SERVICE BULLETIN RCA 2019-08-07

Subject: Reprint of Dynon Avionics SB 080219

Affected Aircraft: RV10 aircraft constructed after 13 December 2011 fitted with a Dynon Avionics autopilot system or any RV10 aircraft retrofitted with a Dynon Avionics autopilot system that includes an SV42T servo shipped from Dynon after 13 December 2011. Note: The SV42T servo is not used on any other model RV constructed by Robin Coss Aviation.

Required Action: Removal of affected servos linear actuator sub-assembly for replacement of the pulley.

Figure 8

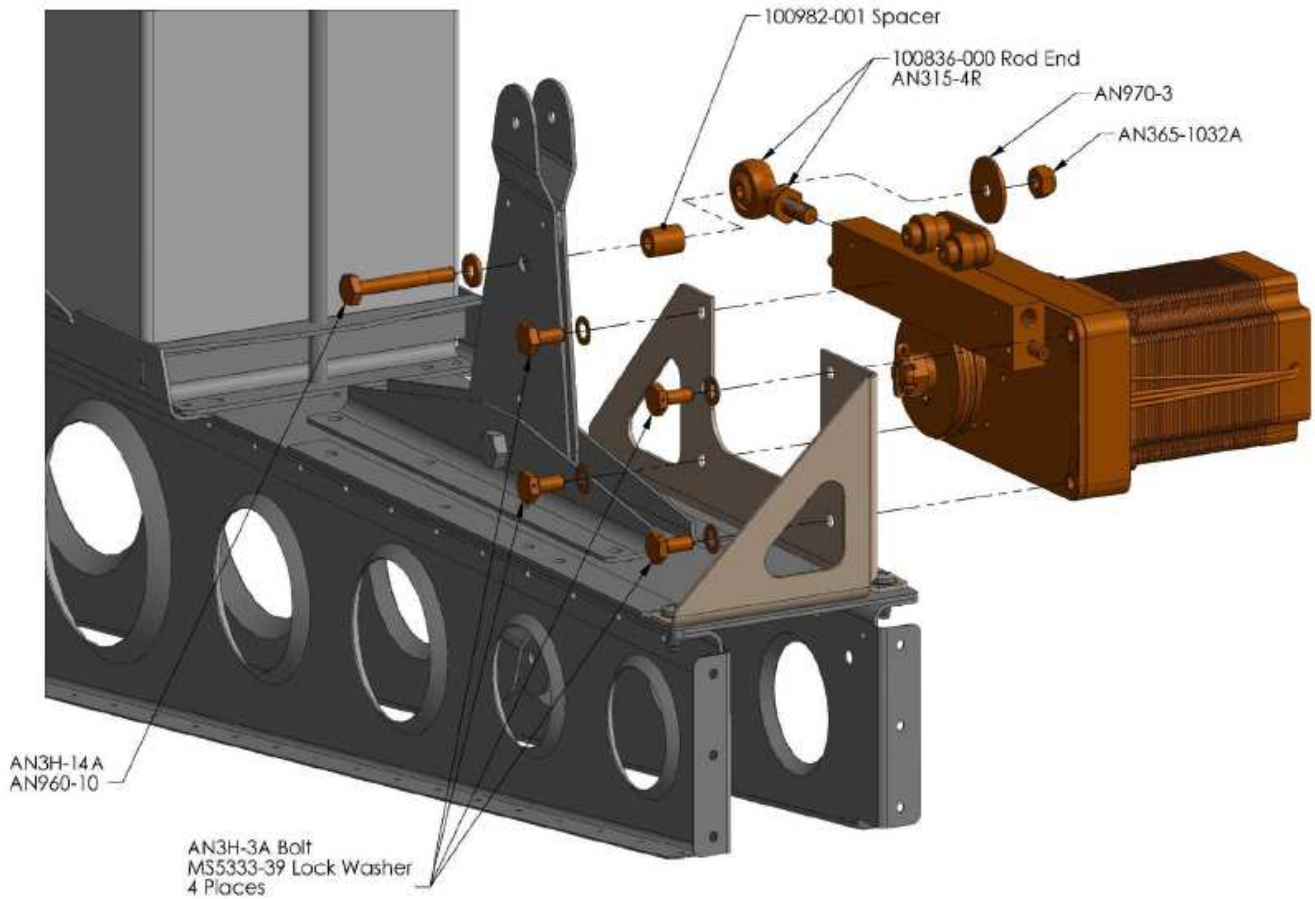
6. Attach the actuator rod end to the elevator bellcrank using the hardware removed during removal (fig. 8) and torque.
7. Carry out a full and free check of the aircrafts elevator control system.

Fig 2: Affected pulley design with crack

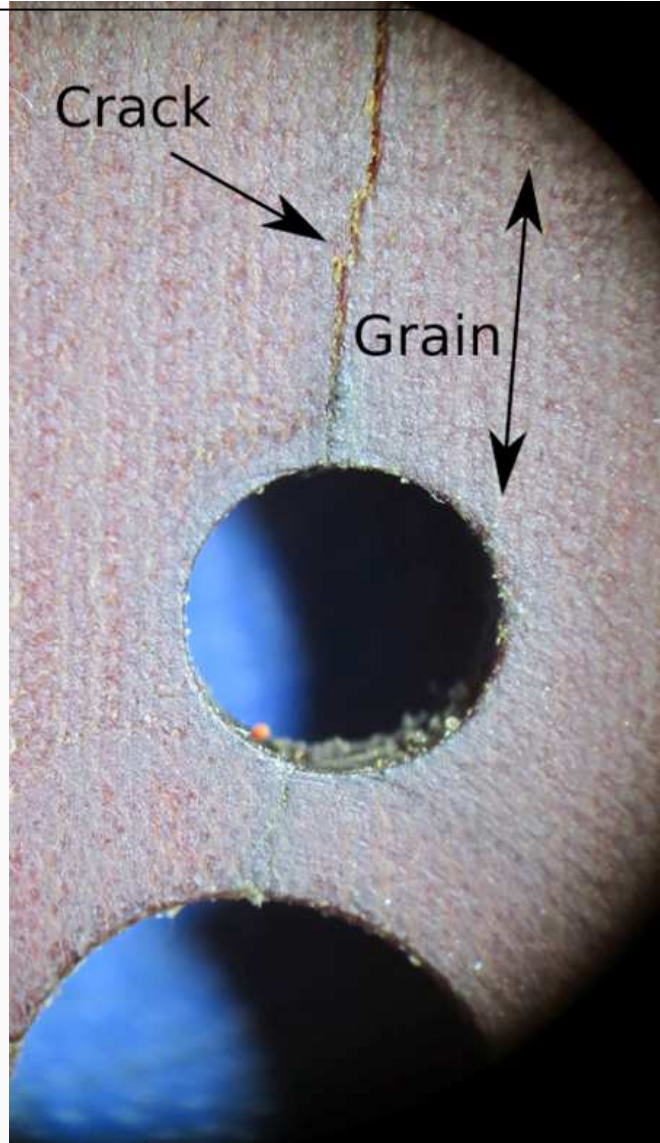
1. If you received your SV42T or linear actuator assembly before 12/13/2011, it is unaffected and can remain in service. If you received your servo, or linear actuator assembly after this date, inspect it as follows.
2. Inspect the pulley for a crack from the center of the pulley through shear screw bore. (Fig 2)
 - It may be necessary to engage the autopilot on the ground and apply force to the control surface in order to load the pulley to make the crack visible.
3. If a crack is found, remove the servo from service and return to Dynon for repair/replacement.
4. If no crack is found, inspect the pulley to determine whether it is affected:
 - Unaffected pulleys have a crosshatch weave pattern in their material weave and a plastic-like smooth texture. Inspect the pulley for texture and visually with a

- Affected pulleys have a unidirectional wood-like “grain”, and a finish that appears dull looks similar to wood. If your pulley matches this description, remove from service and **contact Dynon** for repair/replacement. To remove the servo from service, you may opt to remove the entire servo assembly, or if more convenient you may remove the entire linear actuator sub-assembly by following the “Servo Arm / Capstan Removal and Replacement Instructions” on the **Dynon Documentation Website**. Whether you remove the servo or linear actuator, ensure that any remaining linkages are secured and do not interfere with flight controls. If you choose to remove only the linear actuator, disable the servo circuit electrically to prevent misleading autopilot behavior. This can be accomplished by disconnecting the wiring to the servo and/or removing its fuse or turning off its circuit breaker.

Fig 3: Serviceable pulley design

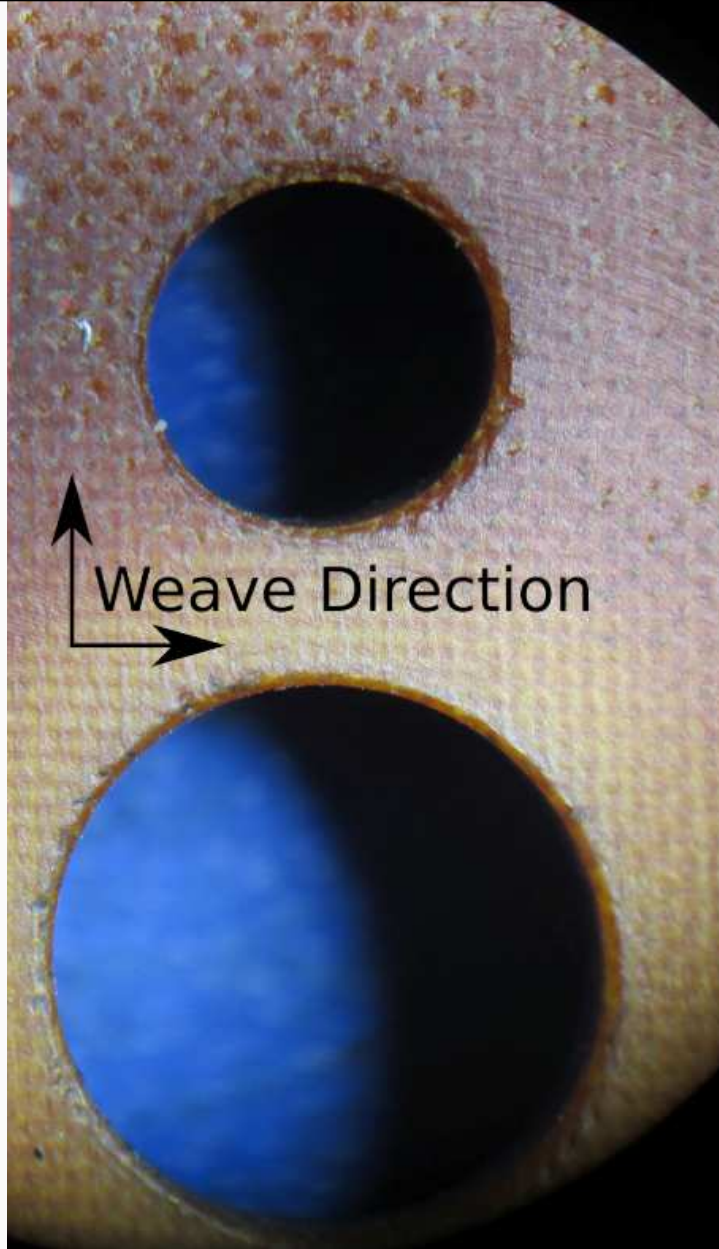
magnifier. If a crosshatch weave pattern is present (Fig 3), the pulley may remain in service.

Fig 2

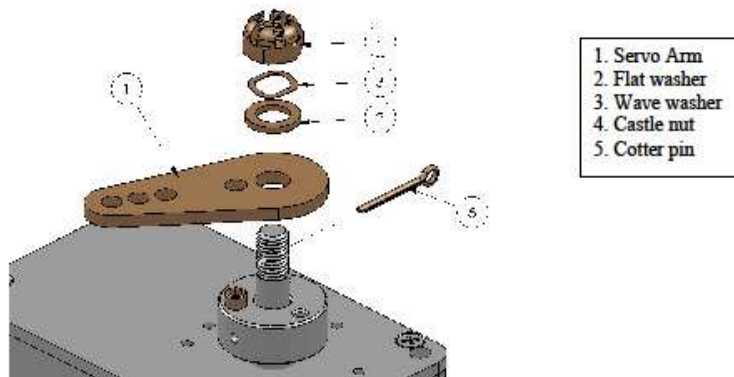
Reverse the disassembly steps to install the remaining hardware. See Figure 2. Assembly order is:

1. Servo Arm/Capstan
2. Nylon Washer
3. Wave Washer
4. Castle Nut (AN310-5)
5. Cotter Pin (M524665-210)

Tighten the castellated nut finger tight, and then using a Torque Wrench, tighten until a slot in the nut lines up with the hole in the shaft for the cotter pin. **DO NOT EXCEED 4.5 in-lb (72 in-oz) torque on castle nut.** Exceeding this torque specification will affect the yield torque of the safety shear screw, compromising the safety-enhancing intent of its design.
